ORIGINATION FORM

Proposed Revisions to a Standard Plans Index
(Please provide all information — Incomplete forms will be returned)

Index Number: 700-091

Index Title: Catwalk Details

Sheet Number (s): 1 of 3

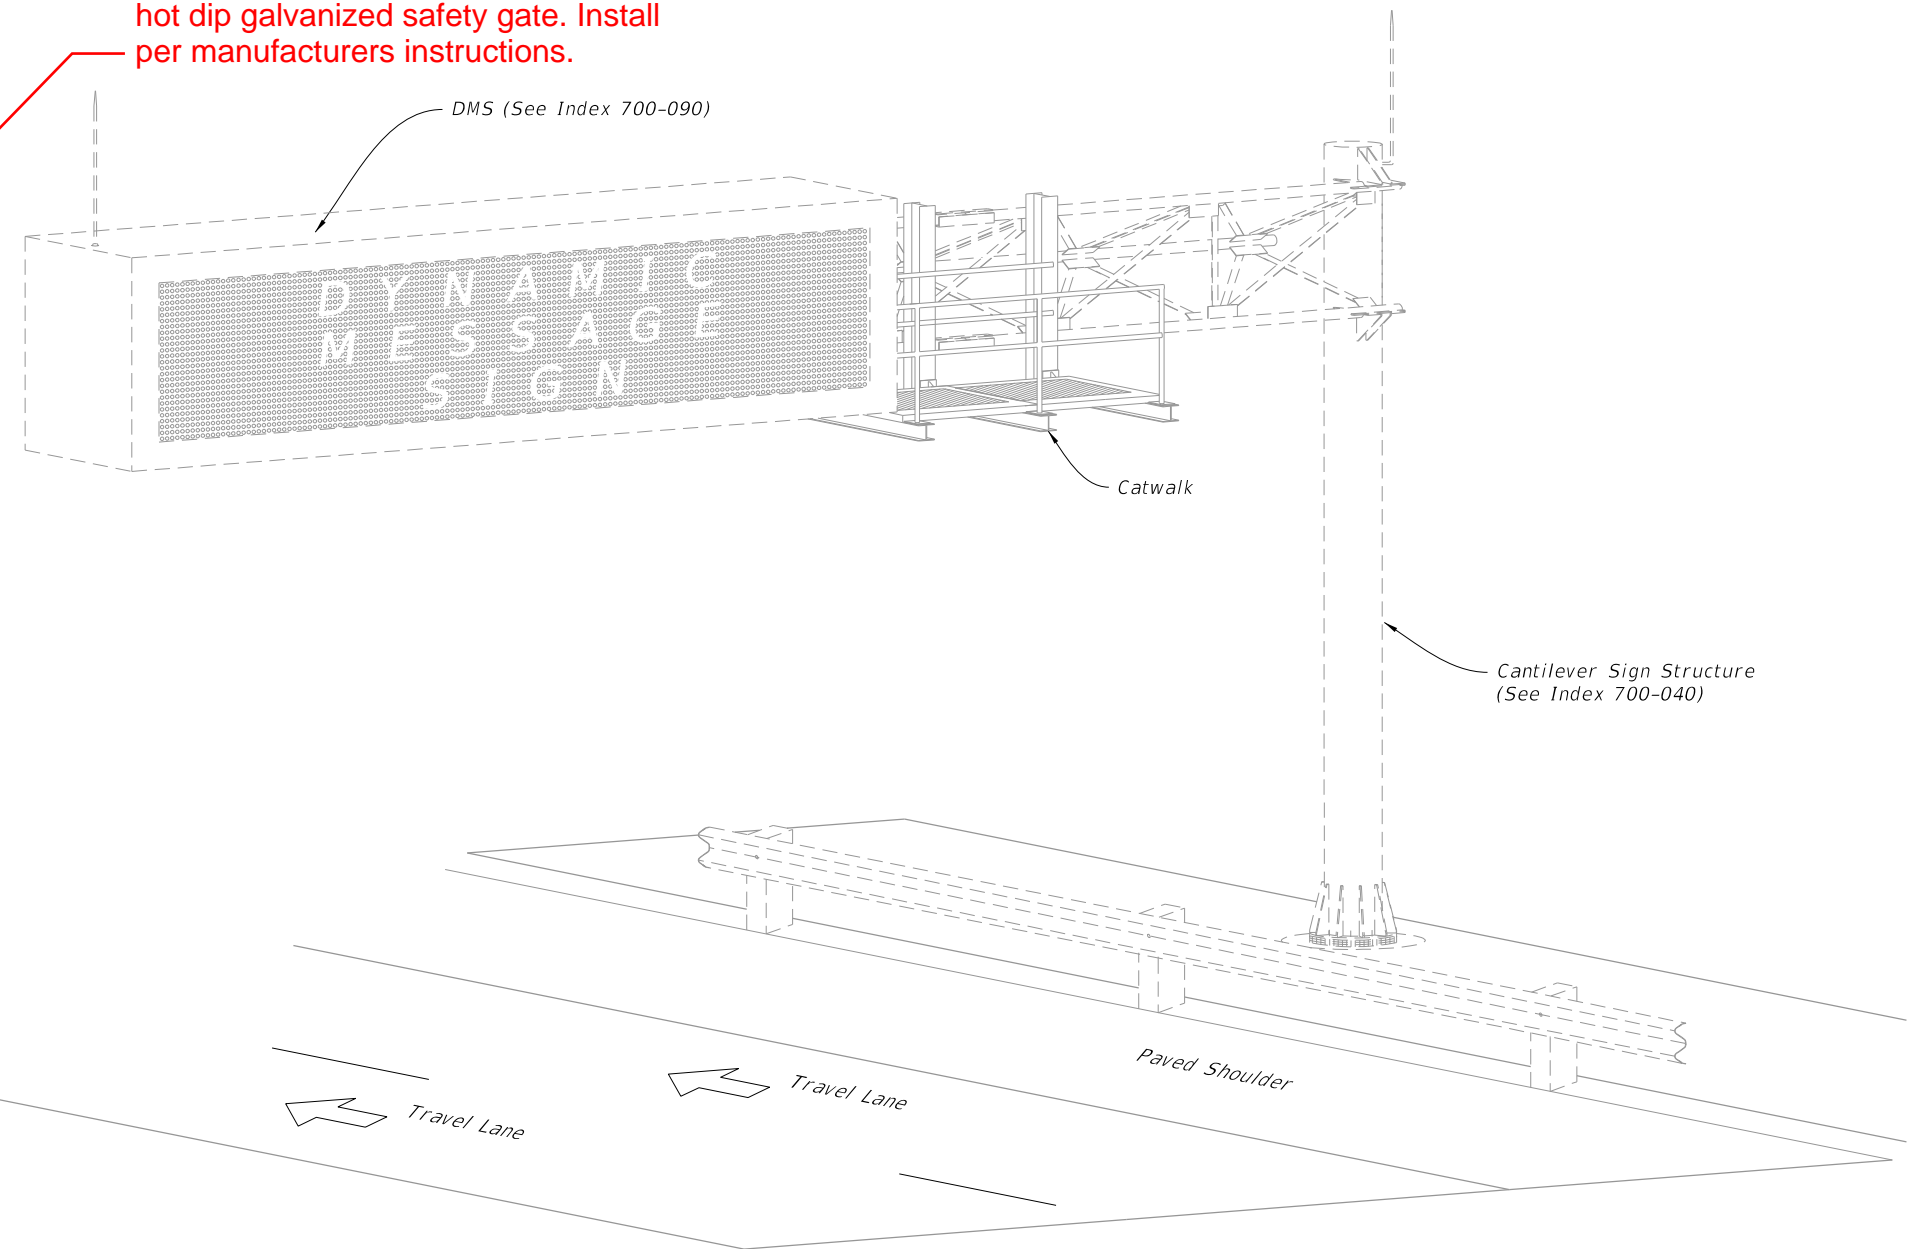
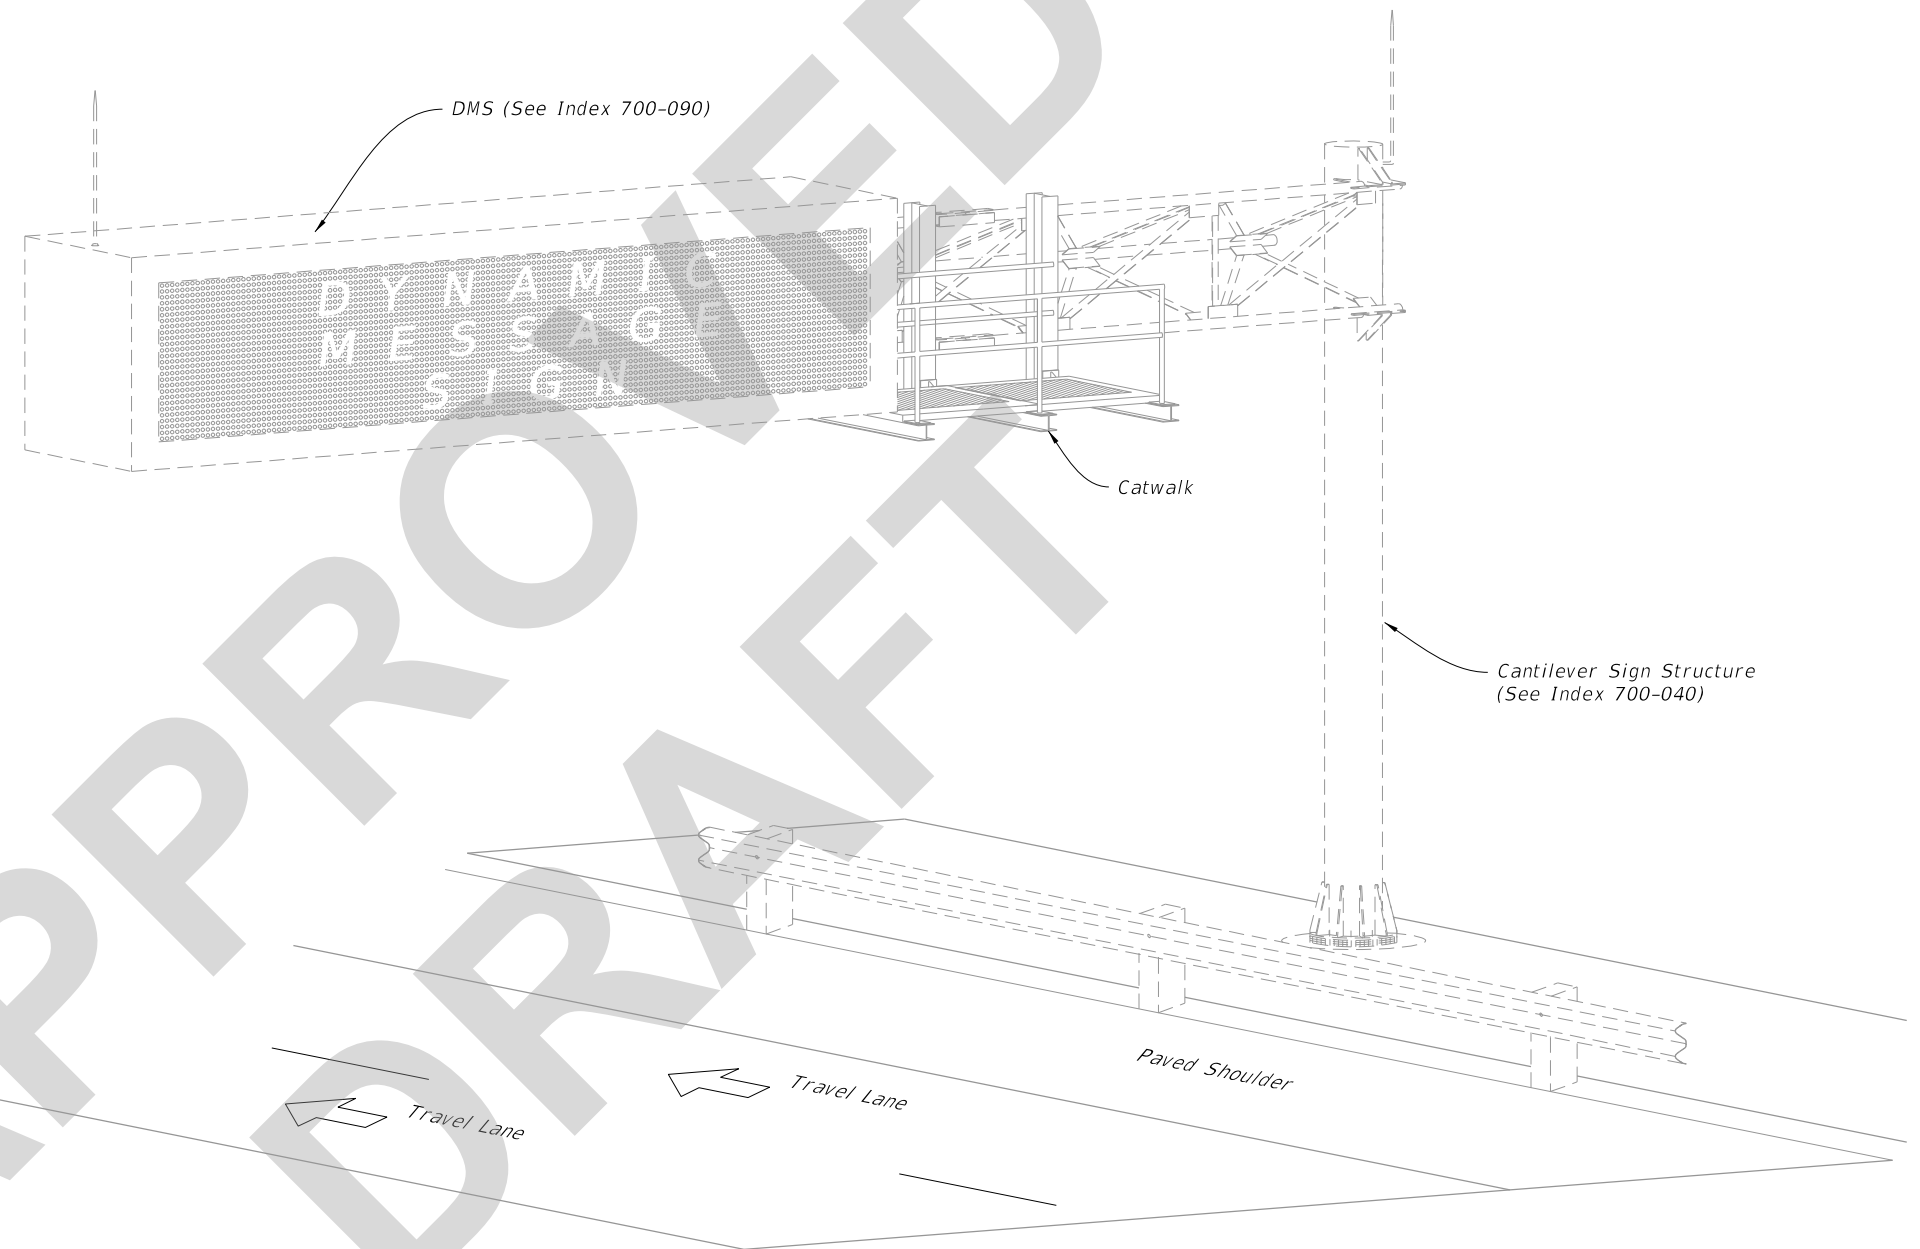
Sheet 1: Updated General Note 6 with more specific language to include Hot Dip Galvanized safety gate and to Install per manufacturers instructions.

6. Supply and install an OSHA 1910 compliant, self closing, ~~corrosion resistant~~ safety gate.
7. Chain link fabric options (2" mesh with knuckled selvage top and bottom for all options):

**UPDATE TO:
hot dip galvanized safety gate. Install
per manufacturers instructions.**

6. Supply and install an OSHA 1910 compliant, self closing, hot dip galvanized safety gate. Install per manufactures instructions.
7. Chain link fabric options (2" mesh with knuckled selvage top and bottom for all options):
